**Landscape Review Committee**  
**Hybrid In-Person & ZOOM Online Meeting**  
**Wednesday, January 22, 2025 - 12:00 PM**

**DATE:** January 22, 2025  
**TO:** Landscape Review Committee Members  
**FROM:** Taylor Graybehl, Senior Planner  
**SUBJECT:** Landscape Plan Review Application (L 50-24)

**DECISION, CONDITIONS, FINDINGS OF FACT AND CONCLUSIONARY FINDINGS FOR THE APPROVAL OF A LANDSCAPE PLAN REVIEW FOR PROPERTY AT 2125 NW 2ND STREET**

- DOCKET:** L 50-24 (Landscape Plan Review)
- REQUEST:** Approval of a Landscape Plan Review for the property at 2125 NW 2nd Street
- LOCATION:** 2125 NW 2nd Street, Tax Lot R4419AC 00300

Figure 3. Landscape Plan

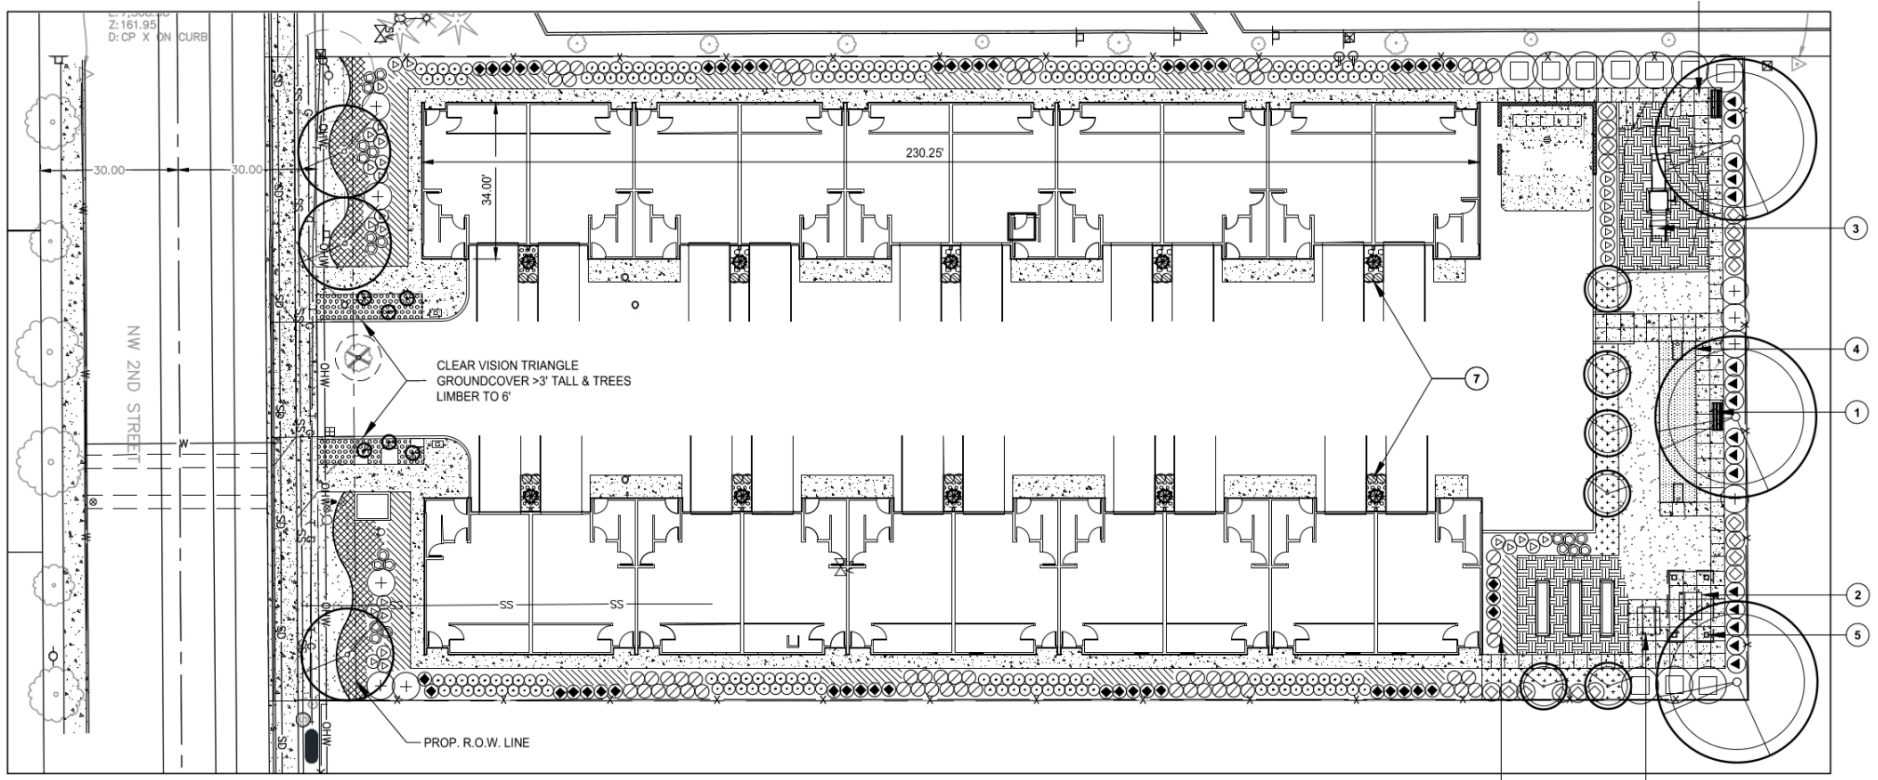
The applicant has proposed developing a twenty-unit *Apartments* use and associated site improvements, including landscaping, irrigation, parking, pedestrian access, utility connections, and vehicular access. **See Figure 3 (Landscape Plan).** **See Figure 4 (Irrigation Plan).** Two rows of buildings are proposed along the west and east property lines, with a parking area in between, landscaping along the perimeter, and an open space area along the northern property line. The landscape plans show an overhead along NW 2<sup>nd</sup> Street, creating potential conflicts between the overhead wire and proposed street trees. Plans indicate 11,350 square feet of landscaping at 25.3% of the site, in compliance with minimum requirements.

Figure 5. Revised Site Plan (received January 10, 2025)

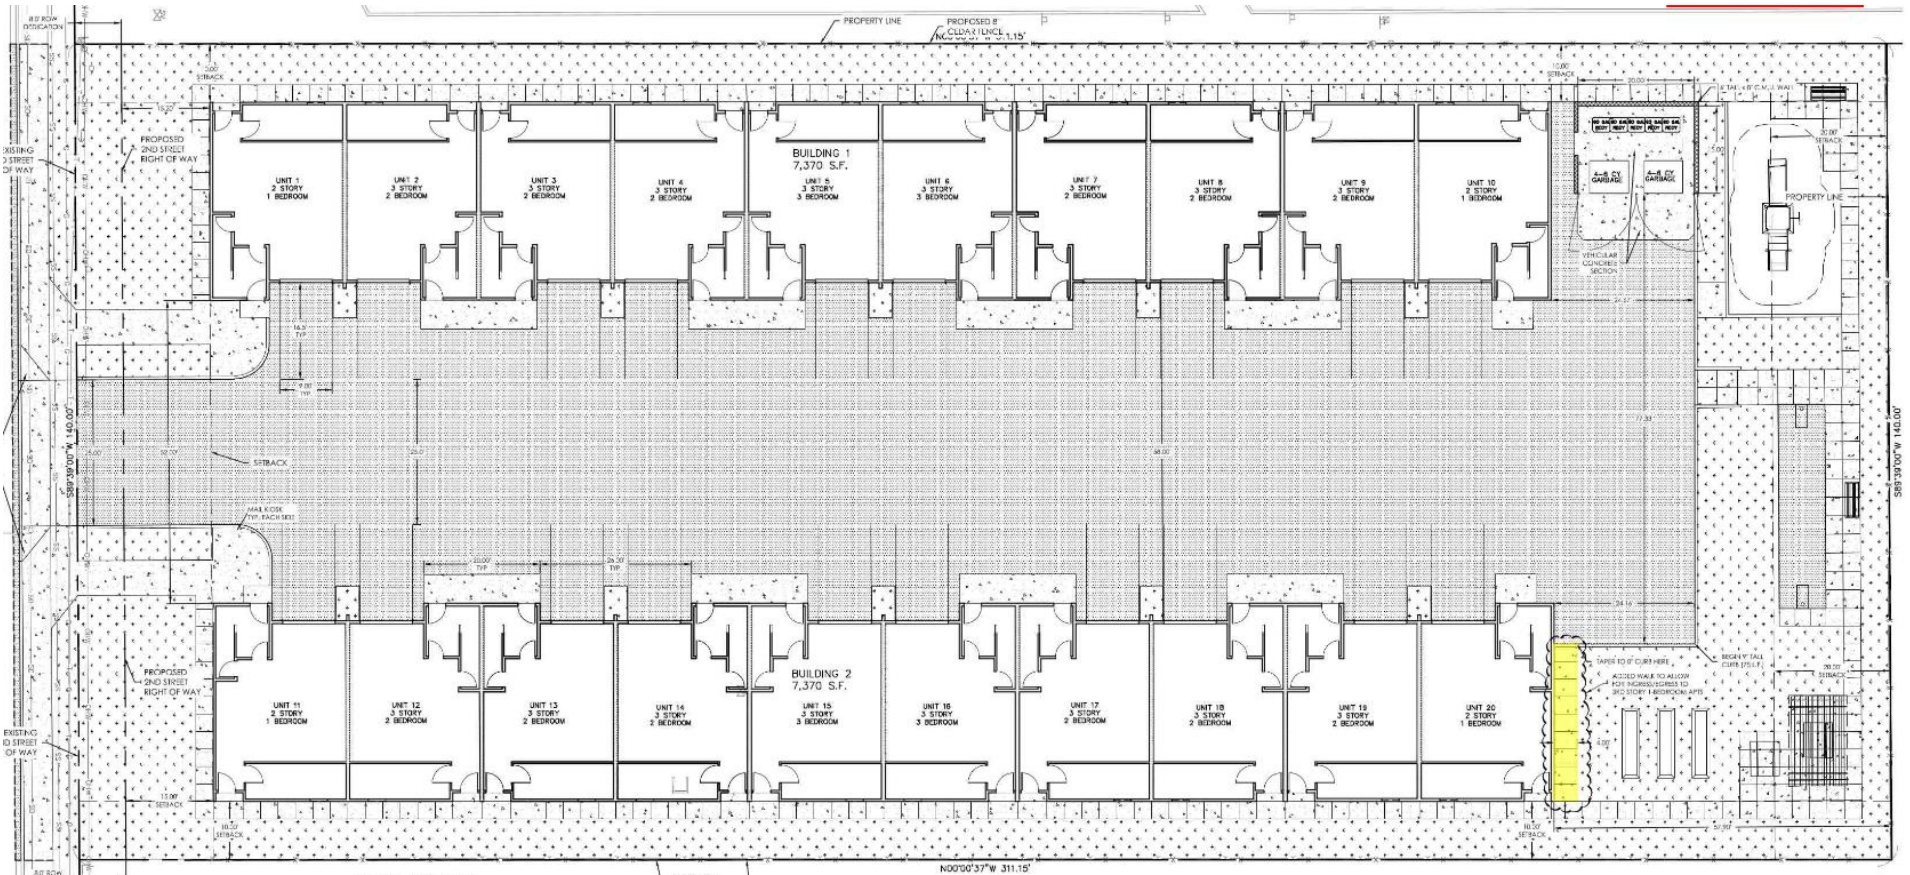
The applicant submitted a revised application on January 10, 2024, proposing adding a pedestrian way along the northern portion of Unit 20 to allow for ingress/egress to the third-story 1-bedroom apartments. The proposed revision would convert an area proposed as plantings to a walkway. **See Figure 5 (Revised Site Plan).**

Figure 7. The area Highlighted in yellow is proposed to be converted from plantings to a walkway to allow for ingress/egress to the third-story 1-bedroom apartments.

Clear Vision Area

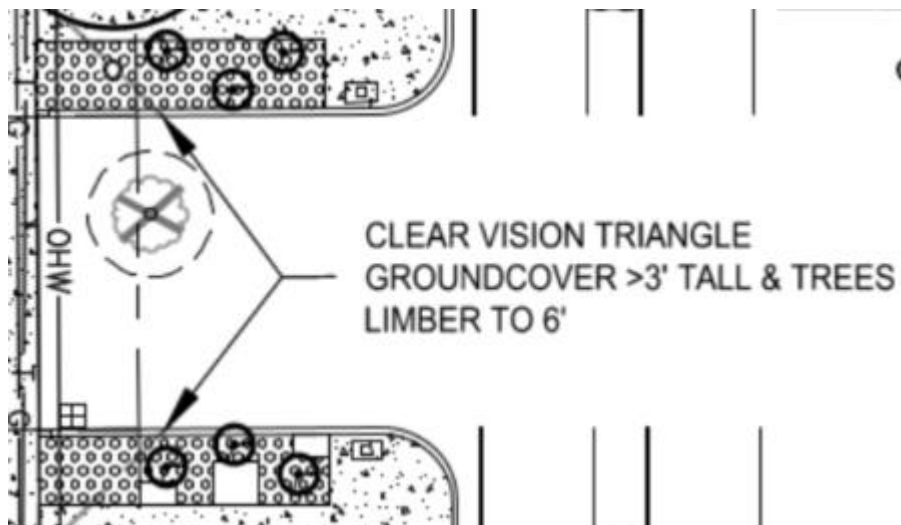
**FINDING: SATISFIED WITH CONDITION OF APPROVAL #20.** The applicant has identified the clear vision triangle and noted that the ground cover will be ">" 3' tall.

The applicant may have accidentally used a greater (>) than sign, instead of a less (<) than sign. A revision to the plans will be required to accurately reflect a height of less than three (3) feet.

21. Prior to the issuance of a building permit, the applicant shall submit a revised landscape plan that correctly reflects the height requirements in the clear vision area. (MMC 17.54.080(B))

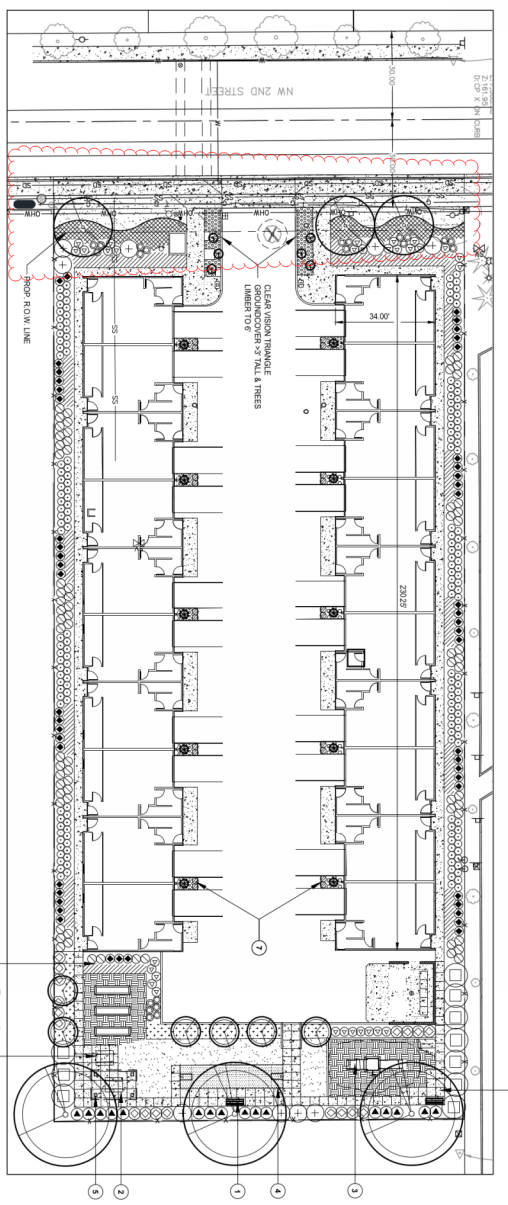
1. The plans show Acer rubrum 'October Glory' as a street tree. The planting site is constrained by overhead wires. Those included both power and communication facilities. Per the approved street tree list, Acer rubrum 'October Glory' is not recommended for areas under wires. Staff suggests that the applicant select another tree be selected, or demonstrate to Planning that the proposed trees can be planted without impacted the overhead facilities.
2. Staff has no other concerns with proposed plantings in the ROW.

3. Note on the plans identifying the Vision Clearance triangle should be amended to refer to “ground cover < 3’ tall & trees limbed to 6””. The plans not groundcover can be greater than 3’.
4. The remainder of the plantings are outside the ROW and thus are outside of our purview.
